# UNITED STATES PATENT AND TRADEMARK OFFICE

APPLICATION NO.	FILING DATE	FIRST NAMED INVENTOR	ATTORNEY DOCKET NO.	CONFIRMATION NO.
10/550,275	06/26/2006	Hisashi Yoshimura	1035-603	3147
23117	7590	10/05/2007		
NIXON & VANDERHYE, PC 901 NORTH GLEBE ROAD, 11TH FLOOR ARLINGTON, VA 22203			EXAMINER ZIMMERMANN, JOHN P	
			ART UNIT 2861	PAPER NUMBER
			MAIL DATE 10/05/2007	DELIVERY MODE PAPER

<b>Office Action Summary</b>	<b>Application No.</b>		<b>Applicant(s)</b>	
	10/550,275		YOSHIMURA ET AL.	
	<b>Examiner</b>		<b>Art Unit</b>	
	John P. Zimmermann		2861

**FIG. 2**

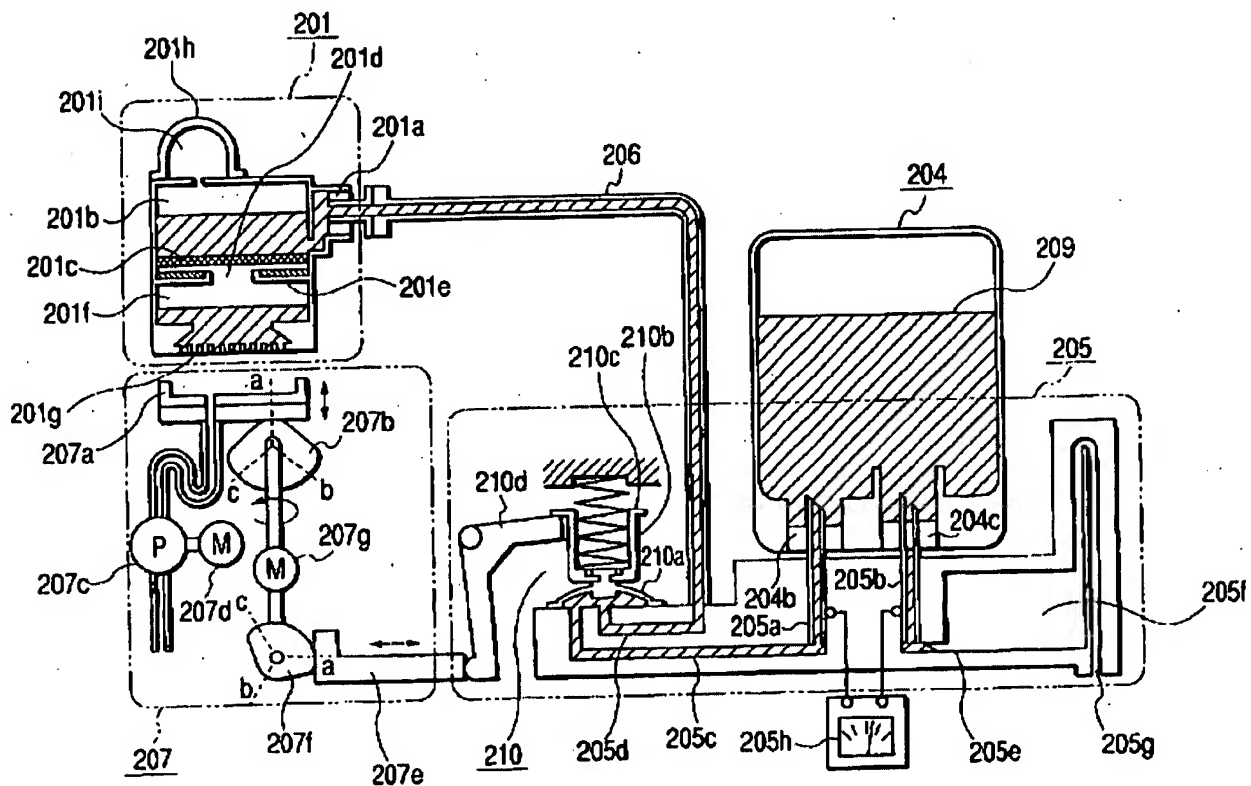
a. As related to independent **claim 1**, Yamanaka et al. teach an ink supply device [i.e. system] (Yamanaka et al. – Figure 2, shown below), which includes an ink tank for containing ink therein (Yamanaka et al. – Figure 2, Reference #204 & #209, shown below) and a tank holder [i.e. supply unit] for holding the ink tank in a detachable manner (Yamanaka et al. – Figure 2, Reference #205, shown below), wherein the tank holder includes pressure control means [i.e. hollow air introducing needle] for allowing the ink and air to circulate between the tank holder and the ink tank (Yamanaka et al. – Figure 2,

Reference #205b, shown below) so that an internal pressure of the attached ink tank has a predetermined value (Yamanaka et al. – Description, Column 13, Lines 5-10 and Column 14, Lines 20-23).

b. As related to dependent **claim 2**, Yamanaka et al. teach the pressure control means includes a pressure control chamber [i.e. buffer chamber] (Yamanaka et al. – Description, Column 13, Line 21 and Figure 2, Reference #205f, shown above) for storing the ink and the air that has flowed out from inside of the ink tank.

**FIG. 4**

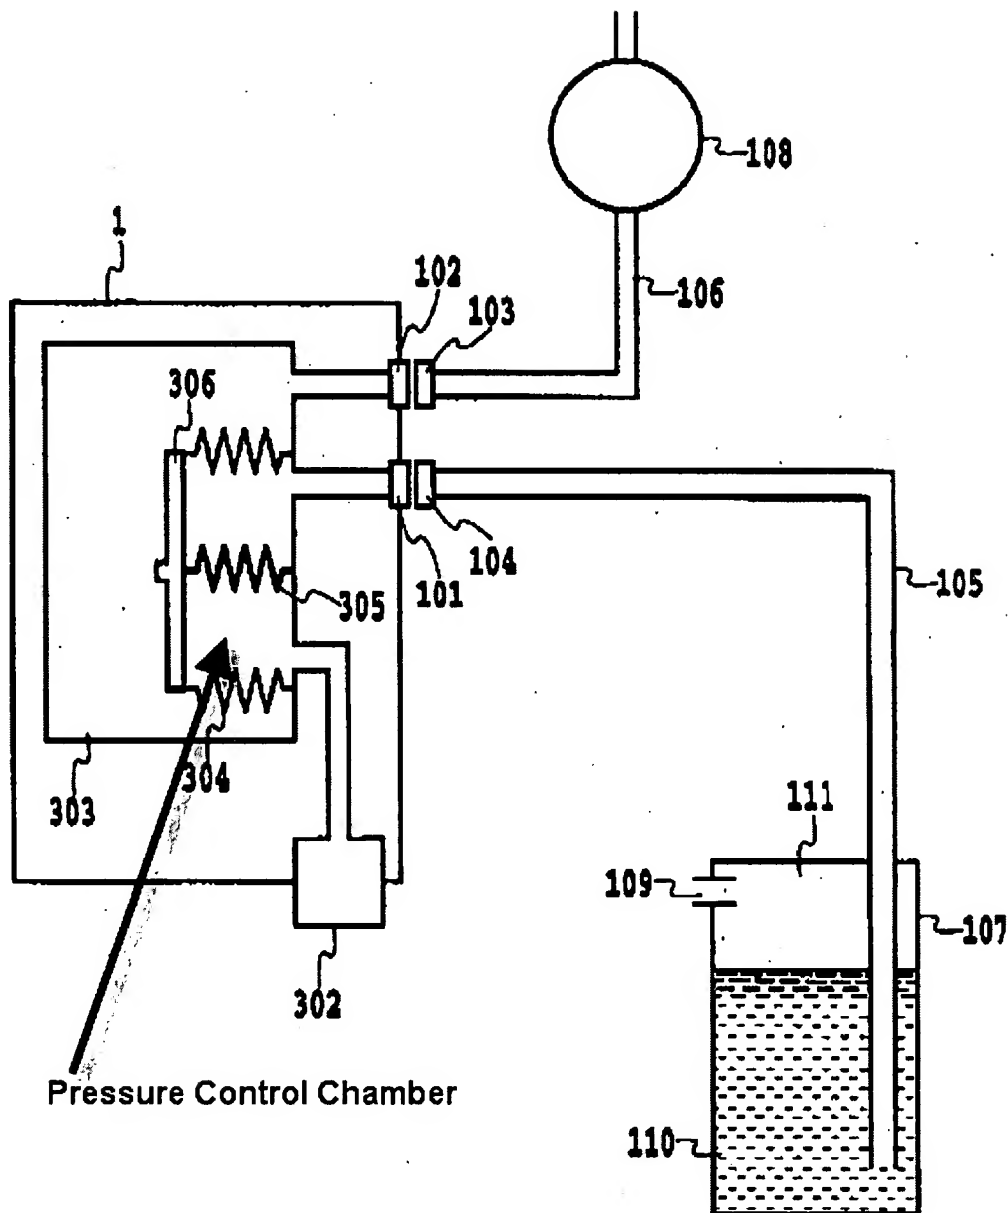
Yamanaka et al. teach the limitations of **claims 1 & 2** for the reasons above but *do not* specifically teach at least a part of a side surface of the pressure control chamber made of a biasing member. *However*, Yoshida et al. teach an ink supply system with a pressure control chamber that includes at least a part of a side surface made of a biasing member (Yoshida et al. – Figure 4, Reference #1, #305 and Arrow, shown below), which biases another surface so that the capacity of the pressure control chamber becomes larger (Yoshida et al. – Figure 4, Reference #306, shown below).

Given the same field of endeavor, specifically a liquid or ink supply system and method with a pressure control chamber, it is apparent that one of ordinary skill in the art at the time the invention was made would have been motivated to combine the ink supply

system with a pressure control chamber incorporating a gravity volume control system as taught by Yamanaka et al. with the ink supply system with a pressure control chamber incorporating a biasing device volume control system as taught by Yoshida et al., in an effort to balance the pressurization of the control chamber and provide negative pressure as needed (Yoshida et al. – Abstract).
